FINAL ENVIRONMENTAL IMPACT REPORT

DEL MAR STATION MIXED USE DEVELOPMENT PROJECT

CITY OF PASADENA

December, 2001

Figure 2
Site Plan

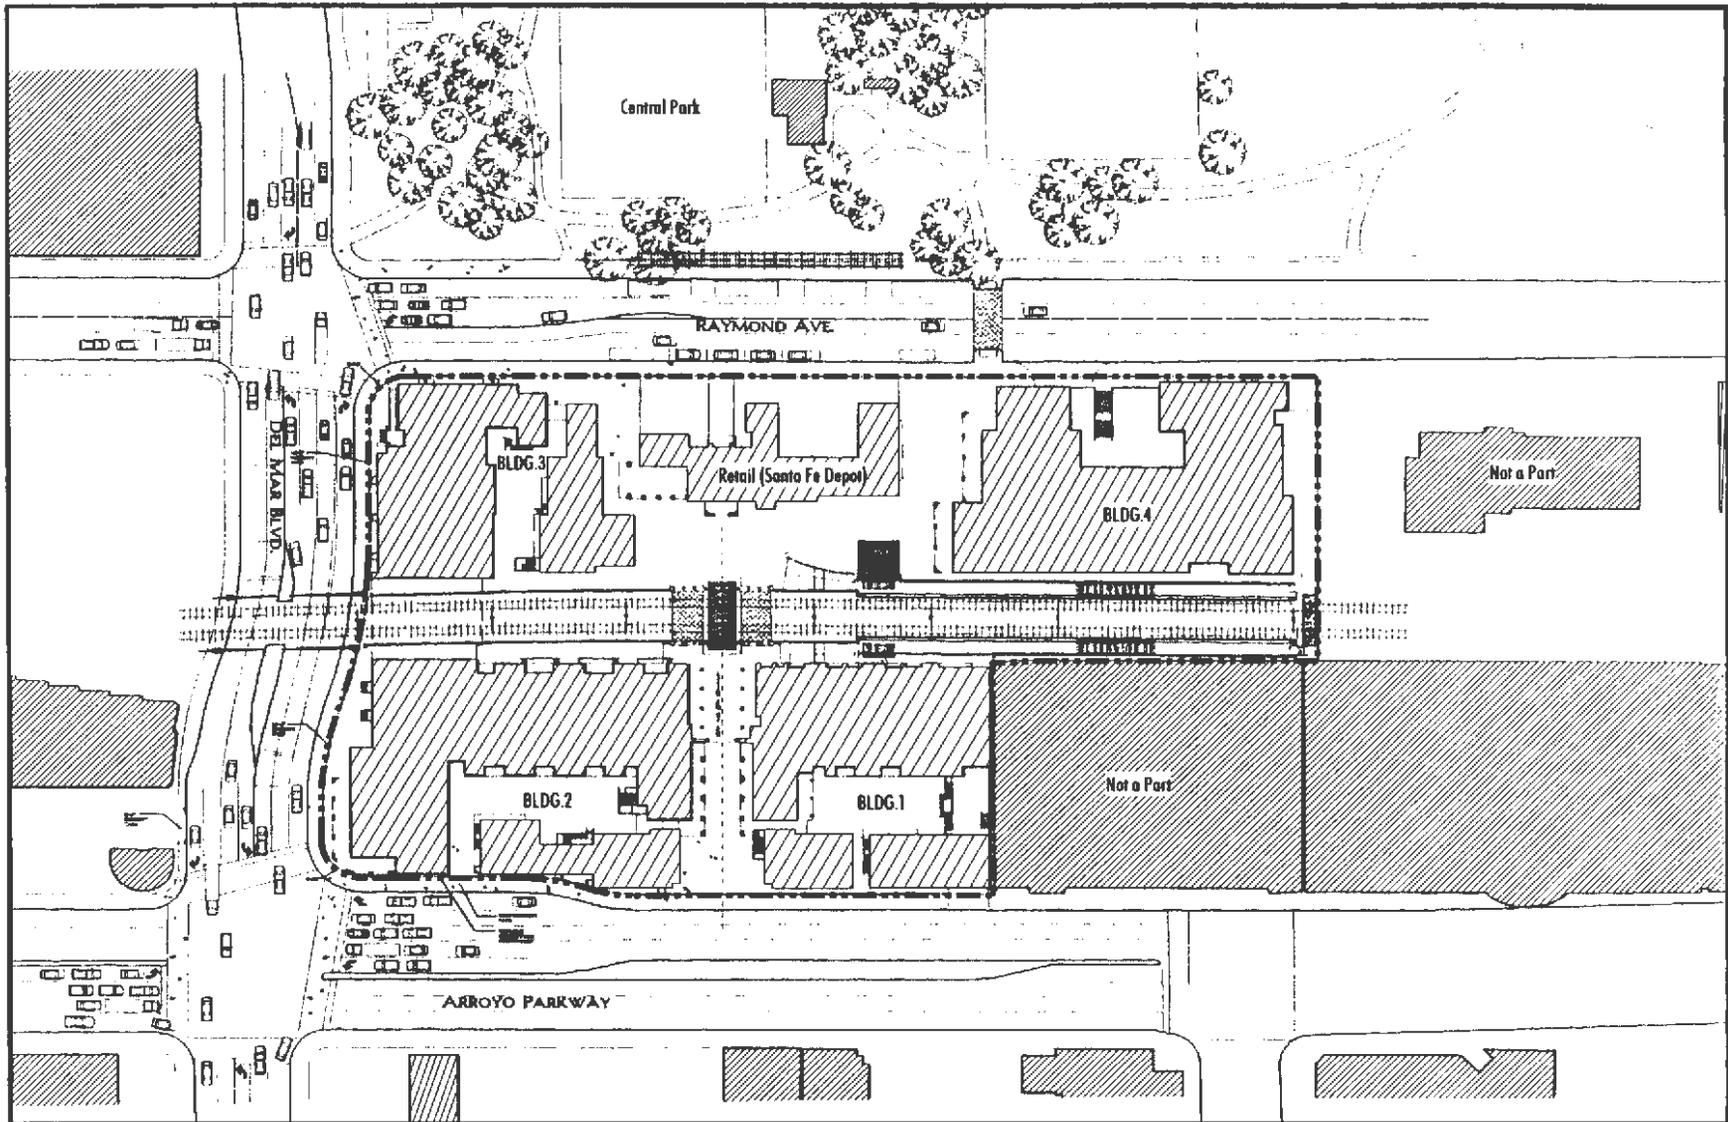
The plan view of the project site shown in Figure 2 includes a breezeway at the southwest corner of the Depot. The breezeway is an outdoor area with a roof and no walls. The nearest support post will be 15 feet from building #3. The Depot itself will be 25 feet from building #3. Therefore, when on the ground, the space between building #3 and the Depot will appear much greater because of the breezeway.

Figure 13
Existing AM Peak Hour
Traffic Volumes

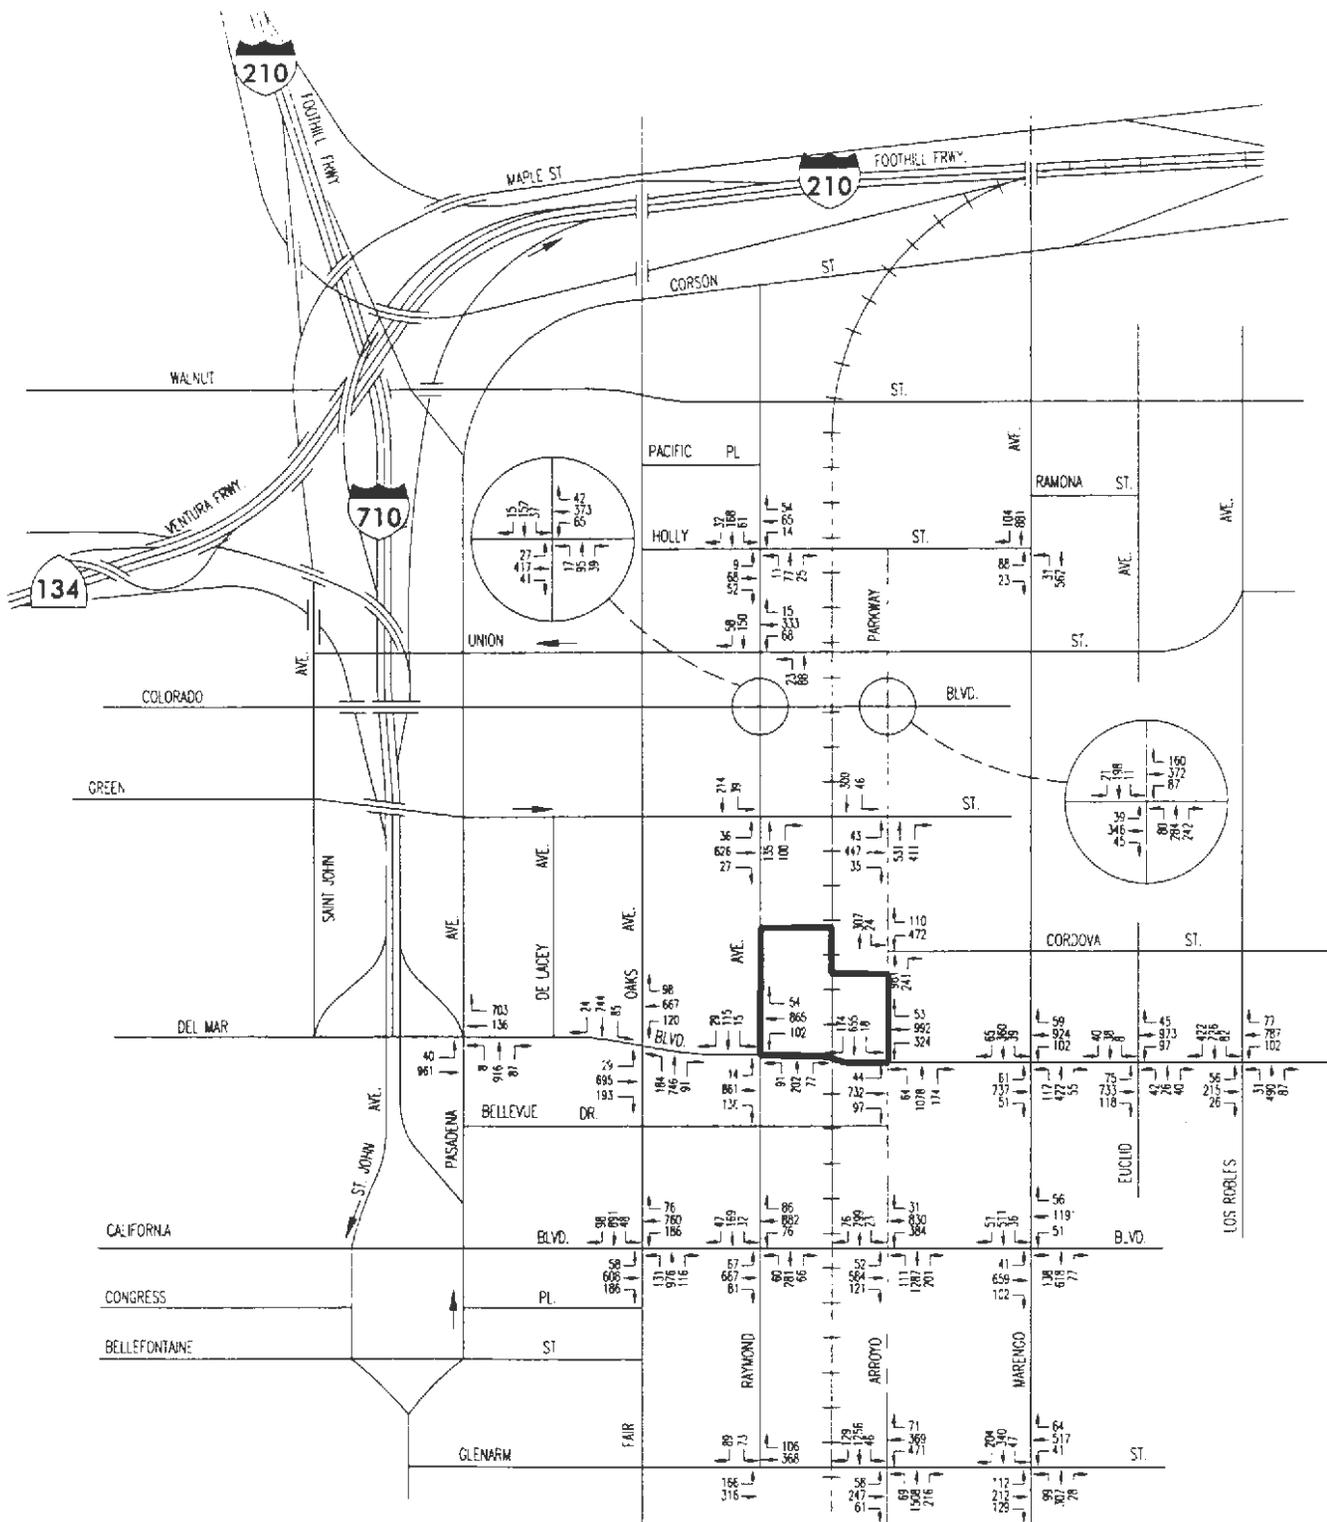
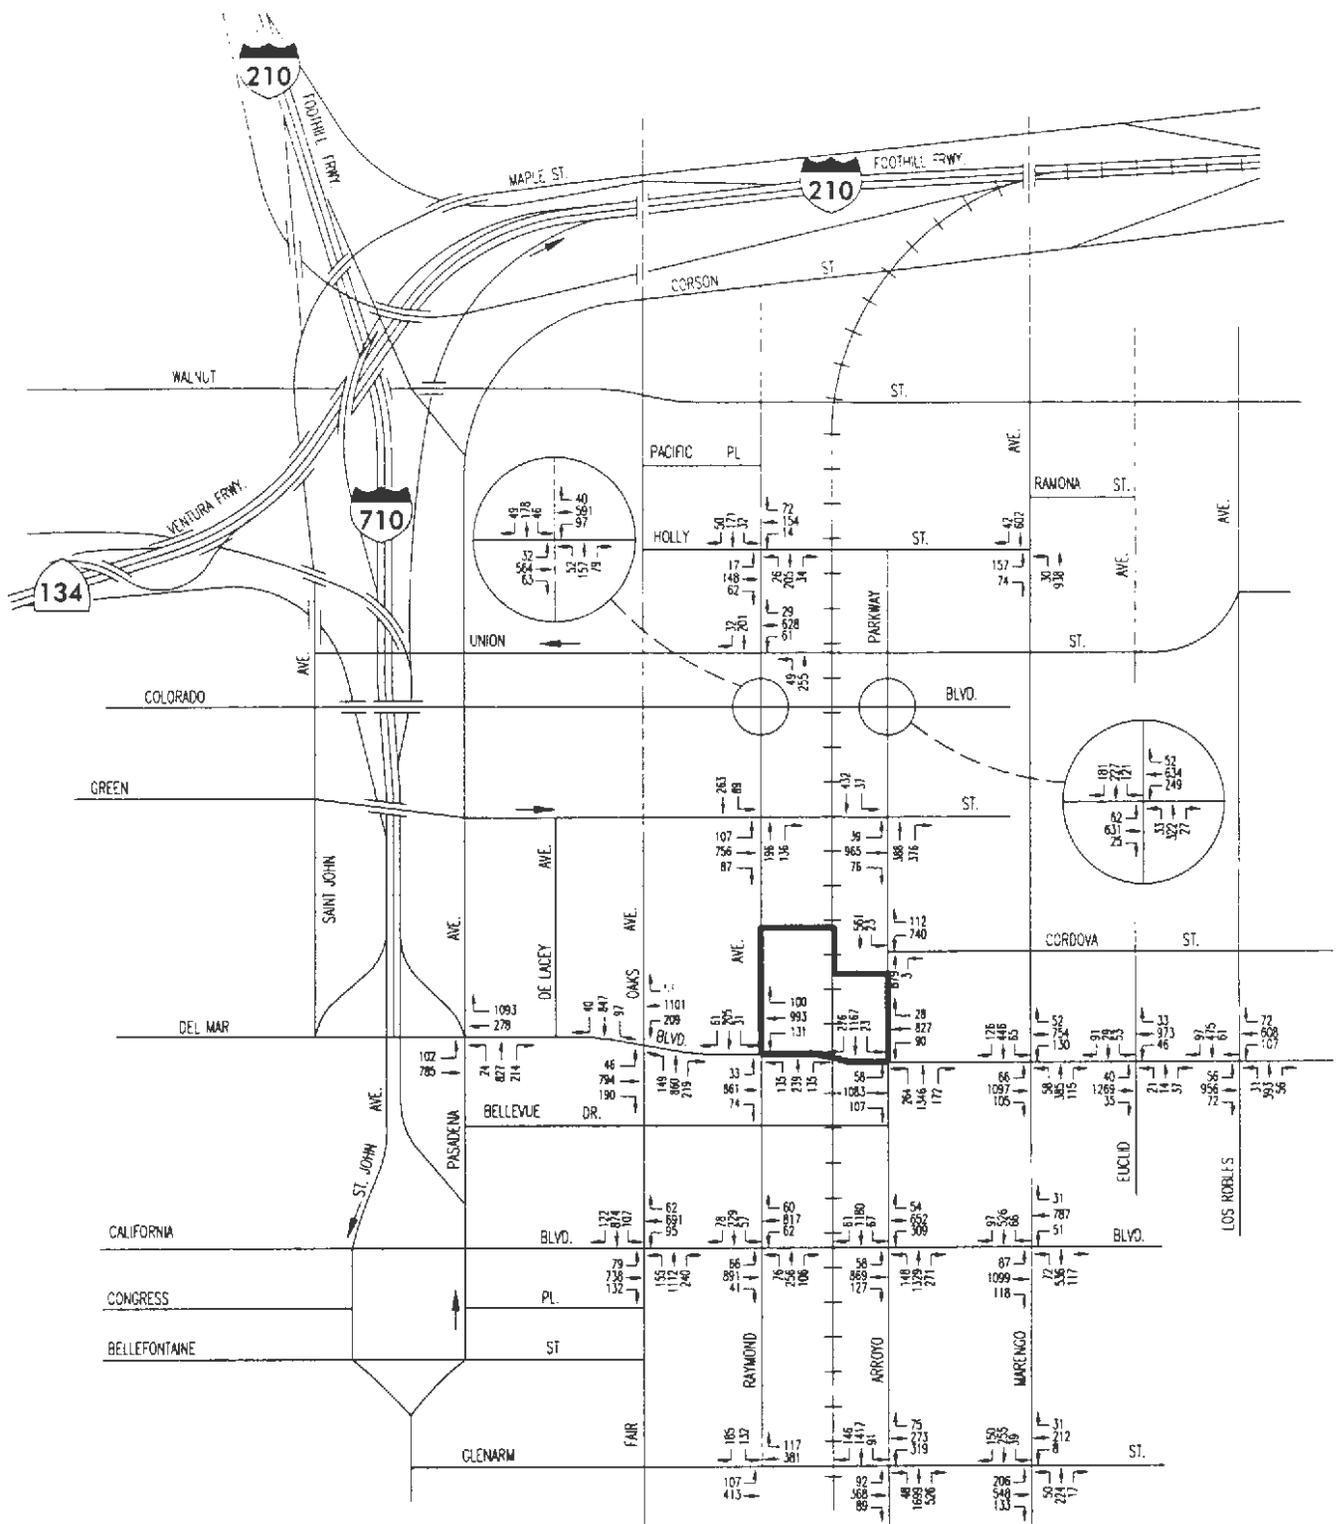
Please provide the traffic volumes at Del Mar Blvd. on & off ramps, see page 52 & 53, Figure 13 & 14 freeway ramps.
